## HISTORIC AND DESIGN REVIEW COMMISSION

March 06, 2019

**HDRC CASE NO:** 2019-094  
**ADDRESS:** 601 BURNET ST  
**LEGAL DESCRIPTION:** NCB 538 BLK 22 LOT S 77.8 FT OF W 55.53 FT OF 8  
**ZONING:** R-4, H  
**CITY COUNCIL DIST.:** 2  
**DISTRICT:** Dignowity Hill Historic District  
**APPLICANT:** Milena Stepanovic  
**OWNER:** Terminal Gravity LLC  
**TYPE OF WORK:** Porch and Window Repairs (Post-work approval)  
**APPLICATION RECEIVED:** February 20, 2019  
**60-DAY REVIEW:** April 19, 2019  
**REQUEST:**

1. Cover an existing front concrete porch with a wood porch under the existing roofline, and
2. Replace non-original square windows with custom single-hung wood windows.

CURRENT PHOTO  
PER APPLICANT  
OF PORCH

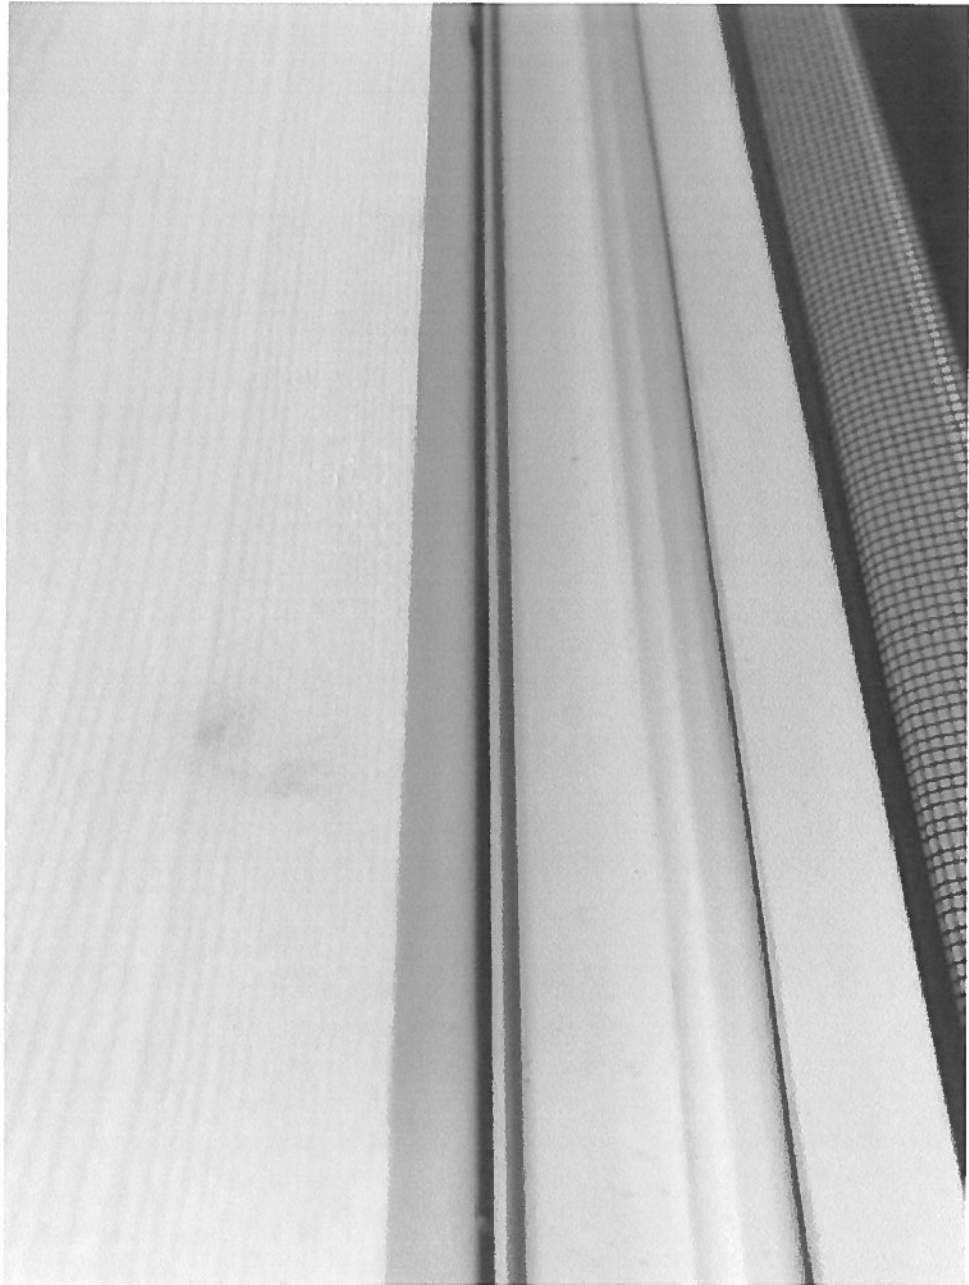
- c. PORCH – The applicant has proposed to install wood decking and new wood columns and railing with lattice skirting on the existing concrete porch. Per the Guidelines for Exterior Alterations and Modifications 7.B.v., the reconstruction of porches should be based on accurate evidence of the original, such as photographs. If no such evidence exists, the design should be based on the architectural style of the building and historic patterns. Staff finds that the concrete porch and wrought iron columns are not original to the structure and may be replaced or covered with a wood porch configuration based on historic evidence. The applicant submitted a design featuring three square columns and a pilaster. Staff finds that porches of this size and in the Folk Victorian style would only feature two full columns. Additionally, staff finds the proposed lattice skirting should instead feature Hardie or lap siding in a configuration that matches the historic profile of a wood deck. All porch elements including the decking, columns, railing, and skirting should feature a simplified historic profile and configuration.

Staff recommends approval of porch reconstruction based on finding c with the following stipulations:

- i. The porch should feature tongue-and-groove decking featuring members that are approximately 3 inches wide and 1 inch tall to be installed perpendicular to the front wall.
- ii. The porch should feature only two full columns, one at the corner and one adjacent to the porch steps.
- iii. Porch skirting should feature a wood or Hardie siding matching the historic structure; faux wood grain texture or lattice skirting should not be used.

601 BURNET ST FRONT ELEVATION

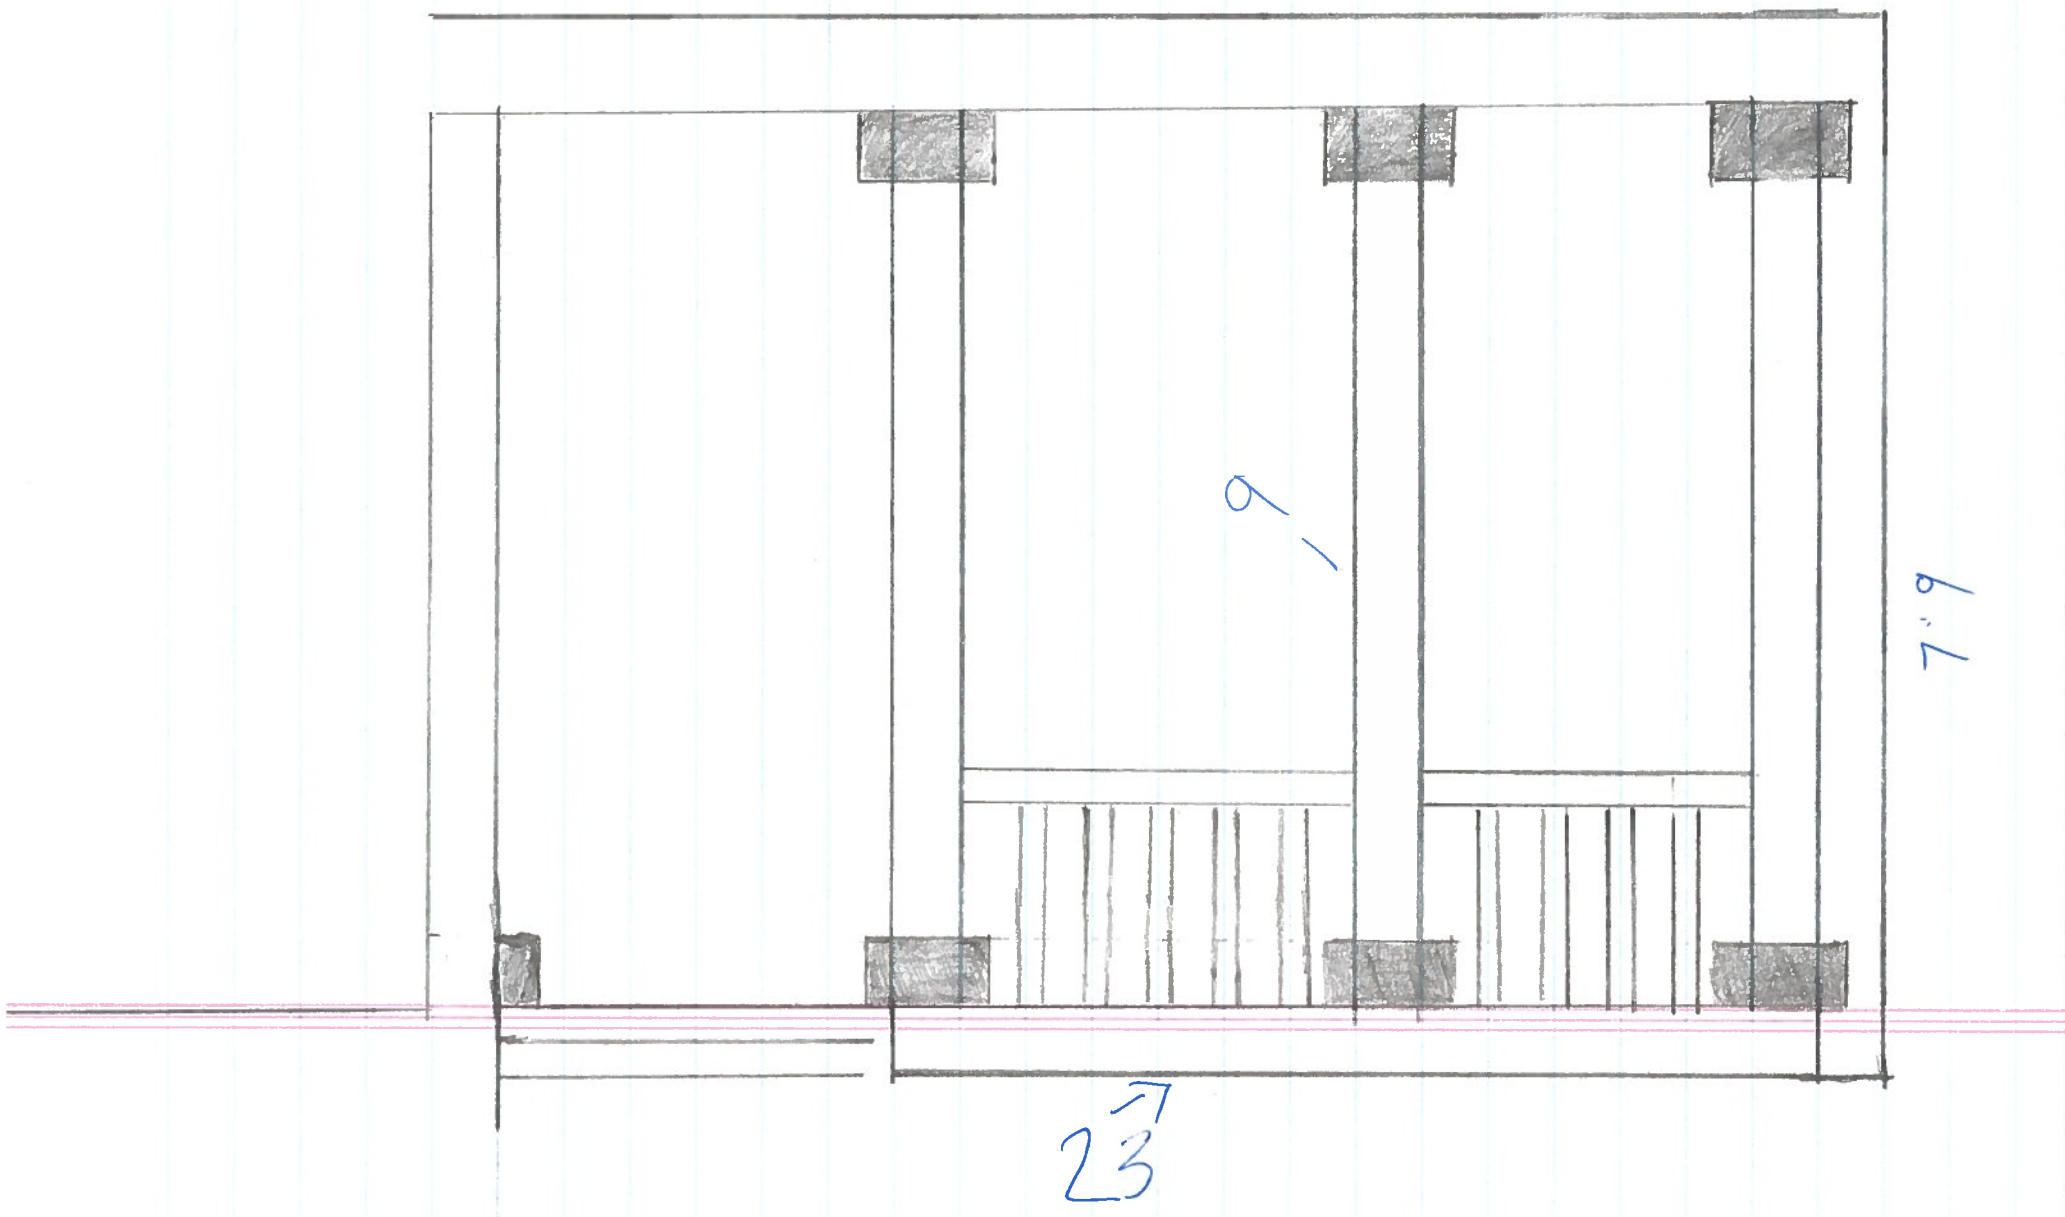
- d. EXISTING WINDOWS – The property from at least 1994 to 2018 featured square windows with faux shutters. These windows are not original to the structure which would have historically featured wood, sashed windows. Staff finds that window replacement with restoration to window opening dimensions and trim would be an improvement to the historic structure.

- i. NEW WINDOWS – The applicant has proposed to install one-over-one wood sashed windows. Per the Guidelines for Exterior Modifications and Alterations 6.B.vii., non-historic incompatible windows should be replaced with windows that are typical of the architectural style of the building. Staff finds that the proposed windows are generally appropriate and should meet the standard specifications for new windows: *Meeting rails that are no taller than 1.25" and stiles no wider than 2.25". White manufacturer's color is not allowed, and color selection must be presented to staff. There should be a minimum of two inches in depth between the front face of the window trim and the front face of the top window sash. This must be accomplished by recessing the window sufficiently within the opening or with the installation of additional window trim to add thickness. Window trim must feature traditional dimensions and an architecturally appropriate sill detail. Window track components must be painted to match the window trim or concealed by a wood window screen set within the opening.* New window trim should feature a dimension and configuration that matches the pattern of the historic structure within the district.

Staff recommends approval of window replacement based on findings d and e with the following stipulations:

- ii. New windows should feature the standard specifications: *Meeting rails that are no taller than 1.25" and stiles no*

*wider than 2.25". White manufacturer's color is not allowed, and color selection must be presented to staff. There should be a minimum of two inches in depth between the front face of the window trim and the front face of the top window sash. This must be accomplished by recessing the window sufficiently within the opening or with the installation of additional window trim to add thickness. Window trim must feature traditional dimensions and an architecturally appropriate sill detail. Window track components must be painted to match the window trim or concealed by a wood window screen set within the opening.*

- iii. New window trim should feature a dimension and configuration that matches the pattern of the historic structure within the district.
